Addendum No. 1 dated 11 May 2017

Pre-bid Meeting Minutes – Addendum No 1

PAL10-00099398 : ITB-2017-079 - Rehabilitate GIE Infrastructure / Package #3 - Desalination Plant

Date: April 2017
Drawing Title: 40m3/hour Brackish Water RO Unit
Rev.No.: 00
Designed by:
Checked by:

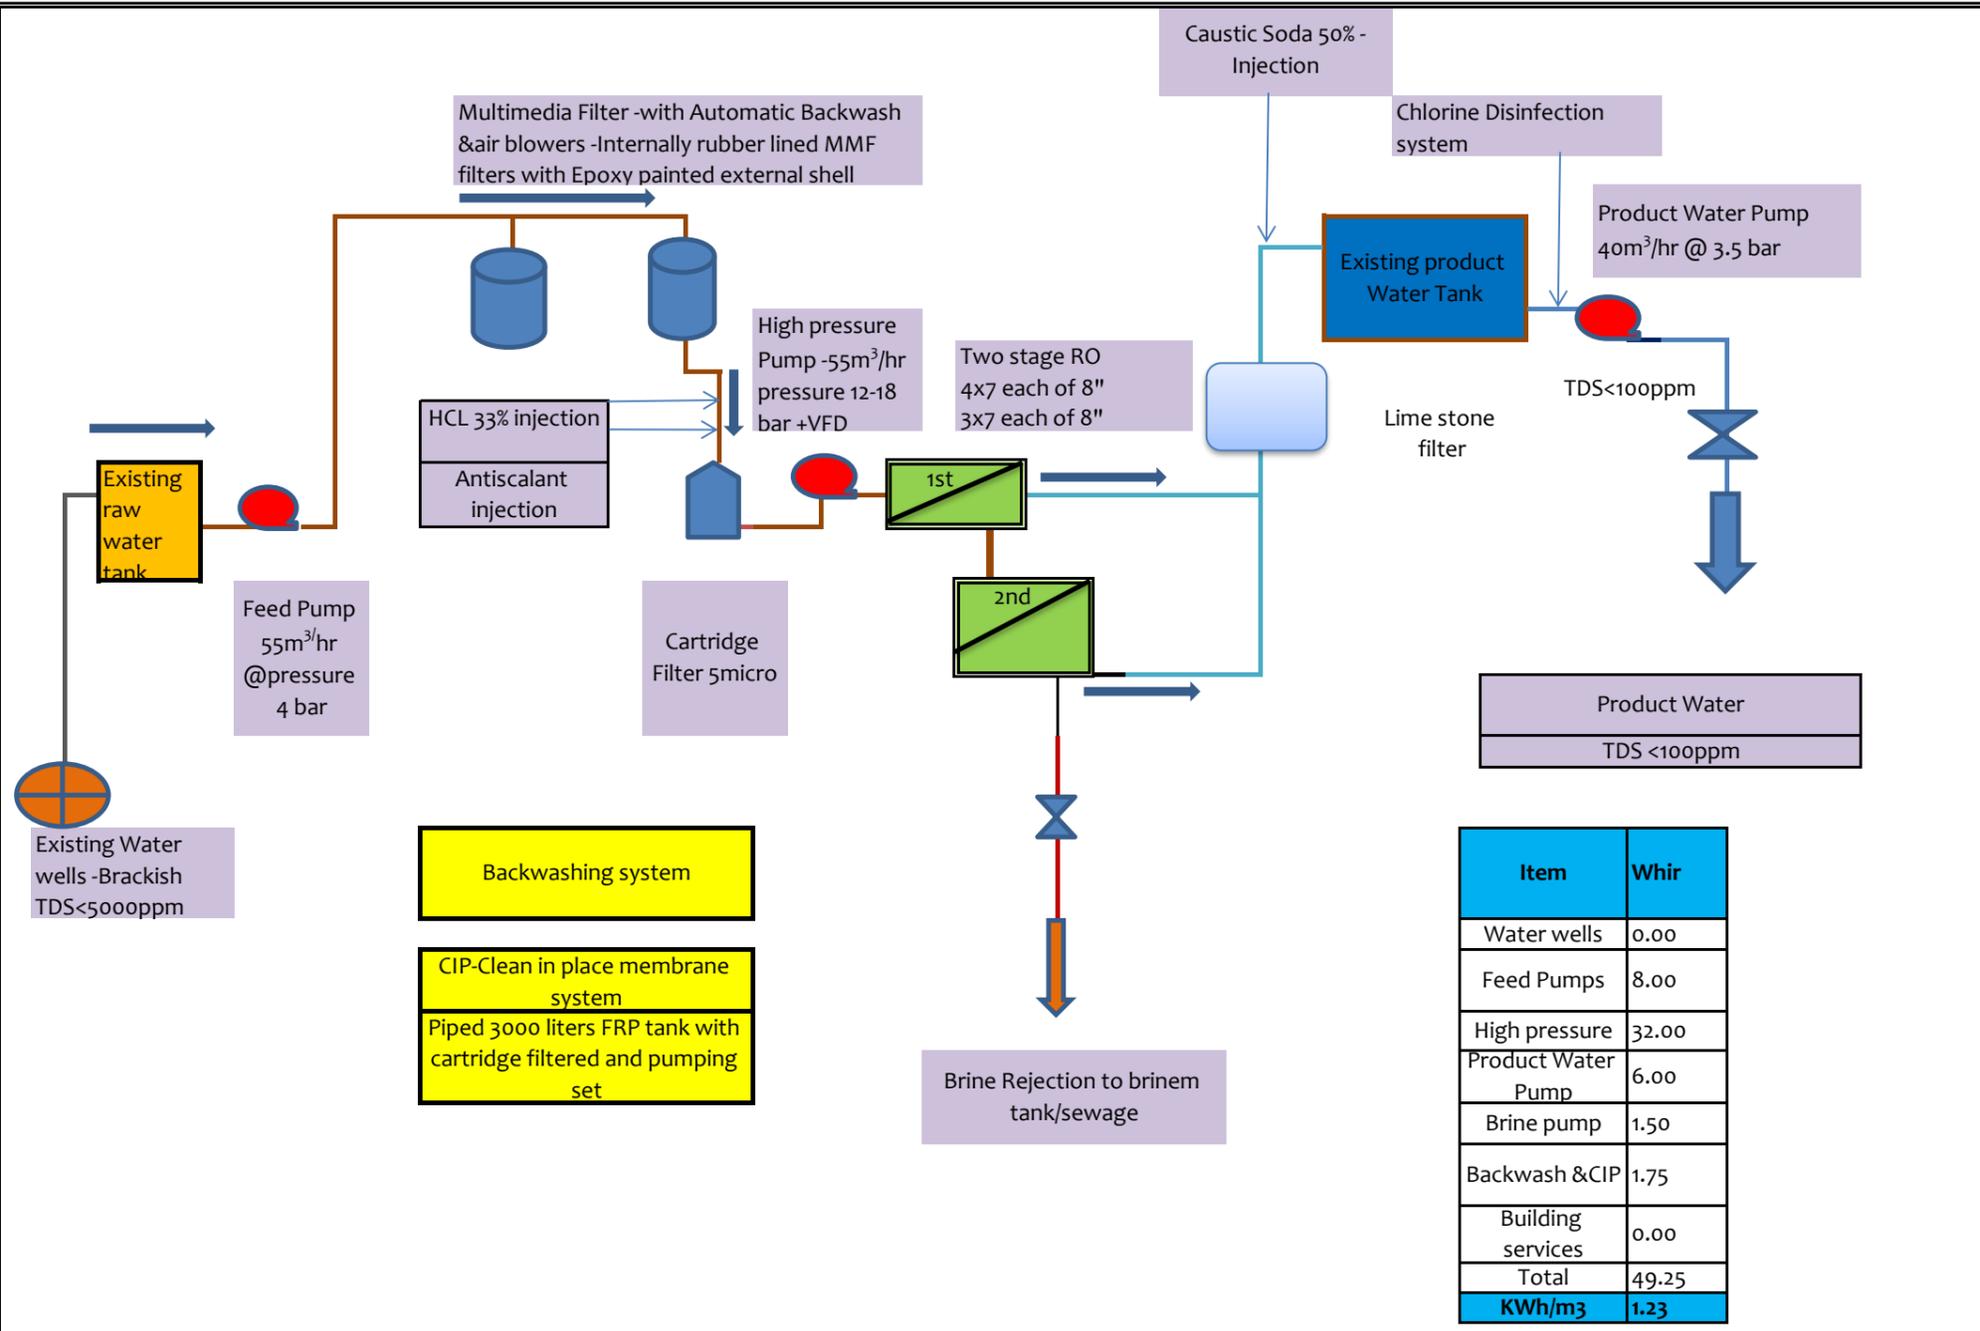
49. The contractor shall consider the attached schematic diagram for the desalination plant.
50. **The original Bill of quantities is hereby replaced by a revised version, attached to this addendum. Interested bidders are there required to dully fill in/ price and submit the revised version of the BOQ along with their bids. In case any bidder uses and submits the unrevised/original version of the bill of quantities, this shall cause UNDP to reject his bid as unresponsive. In case the bidder submits both versions of the BOQ, then UNDP shall consider only the revised BOQ version when evaluation his bid.**

Notes:
All connections shall be made flexible for water ,drainage ,electricity..etc.
The specific power consumption should not exceed 1.25 KWh/m3 measured from well pump up to the product water tank and process recovery should be not less 80% with product water TDS <100ppm

All pipes and fittings ,pumps components in contact with brackish water should be made of CPVC PN80 for low pressure and stainless steel 316 for high pressure side
